RE: Orlando Utilities Commission, Stanton Energy Center (PSD-FL-084)

RE: Orlando Utilities Commission  
SEC Unit 2  
Permit Modification (PSD-FL-084)

The original Best Available Control Technology (BACT) analysis for the Orlando Utilities Commission C. H. Stanton Unit 2 was submitted on March 15, 1991 as part of the Supplemental Site Certification Application. This supplemental NO<sub>x</sub> BACT analysis addresses specific issues identified by the Environmental Protection Agency in letter dated July 2, 1991. Assumptions regarding plant, fuels and evaluation criteria remain the same as presented in that document. The substantive issues identified for further information submittal included the effects of low NO<sub>x</sub> burners on carbon losses, and a detailed technical and economic evaluation for installation of a selective catalytic NO<sub>x</sub> emission reduction (SCR) system on Stanton 2. The following discussion addresses these specific issues identified.

This is to acknowledge receipt of your request for a modification to your previously issued Prevention of Significant Deterioration (PSD) permit transmitted by letter dated March 18, 1991, as well as the additional in

Figure 7. Cumulative probability curve for major western Kentucky coals with respect to the EPA compliance standard.

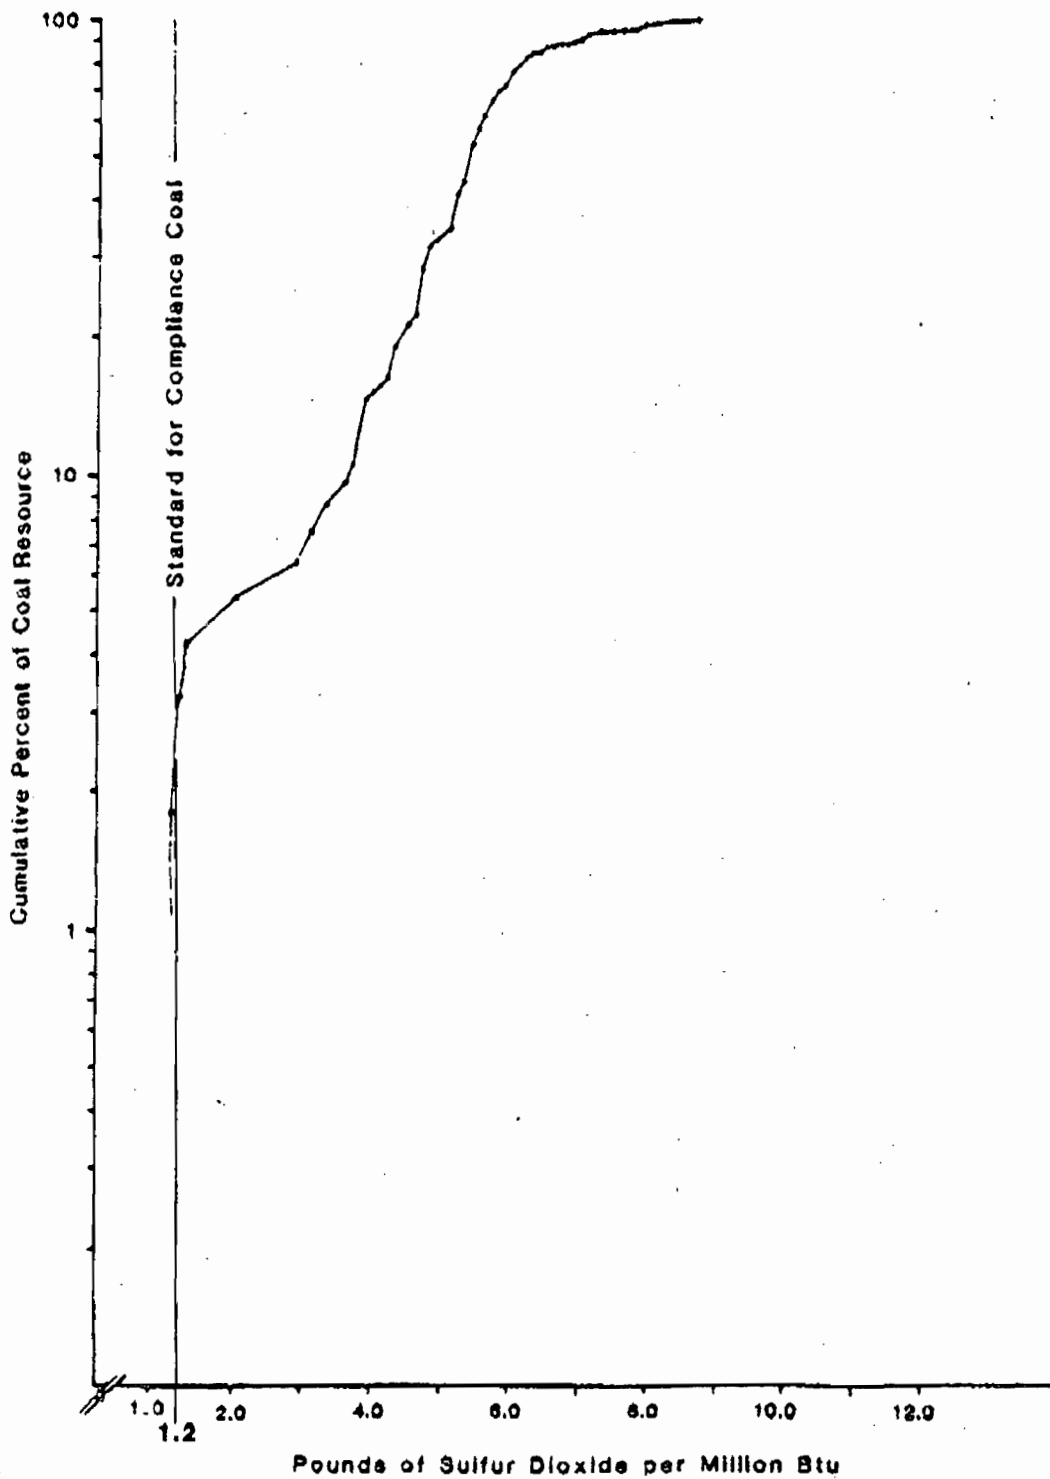
I located a report that he worked on which shows the distribution of coal resources (not economically recoverable reserves) by their sulfur content. See attached Figures 1, 2. As you can see there is a marked difference between the quality and quantity of E. KY and W. KY coals.
